Park Street Triangle Traffic Study

Final Report

Subject: Final Report for Park Street Triangle Traffic Study [P04047.7]

RESPONSES TO PUBLIC COMMENTS AND QUESTIONS AT THE COMMUNITY MEETING ON DECEMBER 1, 2005

Figure 15
ALTERNATIVE 1.5 REFINED 23RD AVENUE CLOSURE

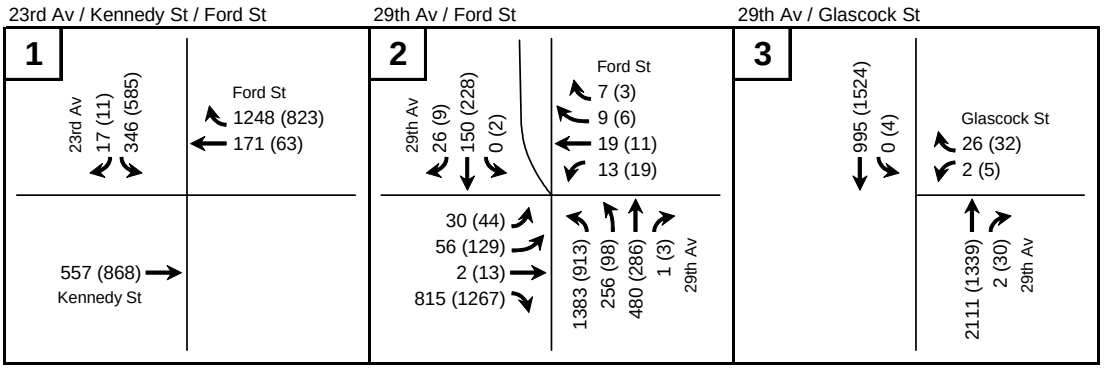
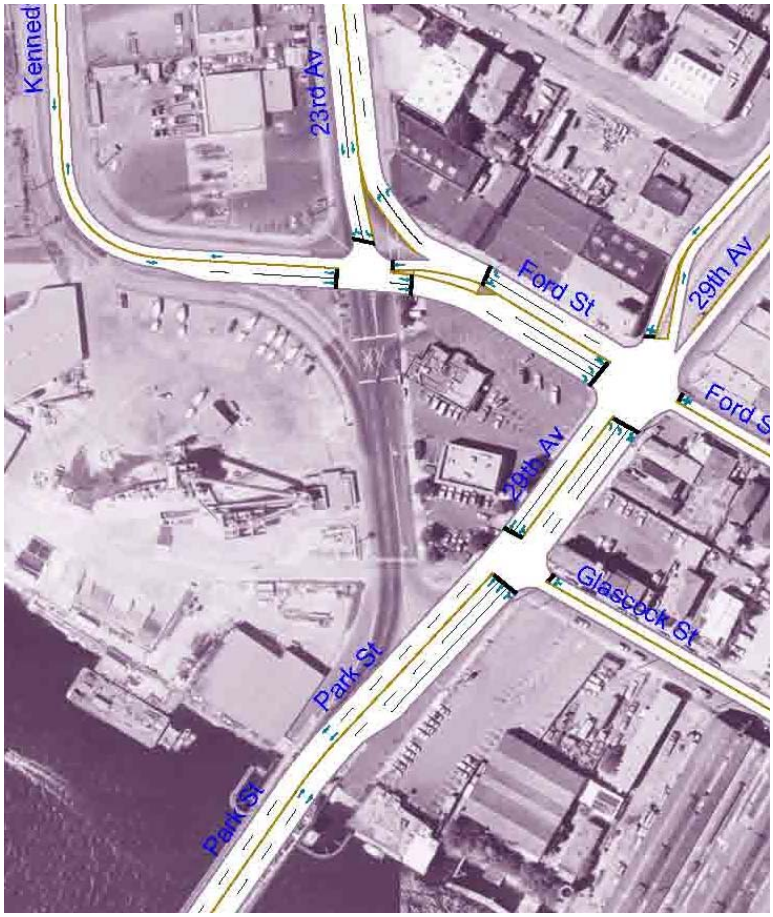
Comment/Question #7: The raised median proposed for Alternative 1.5 will block access to the business in the middle island.

Comment/Question #34: Philip Ho: Under Alternative #1.5, the proposed multi-purpose trail crosses the RR track within the 29th/Glascock intersection at a very small angle of about 15 degrees. This is problematic for bikes, wheelchairs, and strollers. RR tracks are very smooth and slippery (especially in wet weather) compared to regular AC or rubberized AC surfaces. For safety reasons, crossings at RR tracks should ideally be at 90 degrees where possible. Let's discuss how we can resolve the trail alignment at the RR tracks.

Response #7: For Alternative 1.5, a raised median would be necessary to provide safe and efficient traffic flow. Northbound vehicles on 29th Avenue and westbound vehicles on Ford Street would have to make a U-turn at a signalized intersection to access the parcel in the existing middle island.

Response #34: The location of the 29th Avenue Bay Trail crossing on the south side of the Glascock Street intersection would require cyclists and other wheeled vehicles on the trail to cross the railroad tracks at a very sharp angle. A crossing on the north side of the Clascock Street intersection would not require trail users to cross the tracks as they cross 29th Avenue but would require them to cross Glascock Street and cross the tracks at a right angle. This north crossing would be better for trail users but would require relocating the trail further to the north where the 7-Eleven store is currently located.
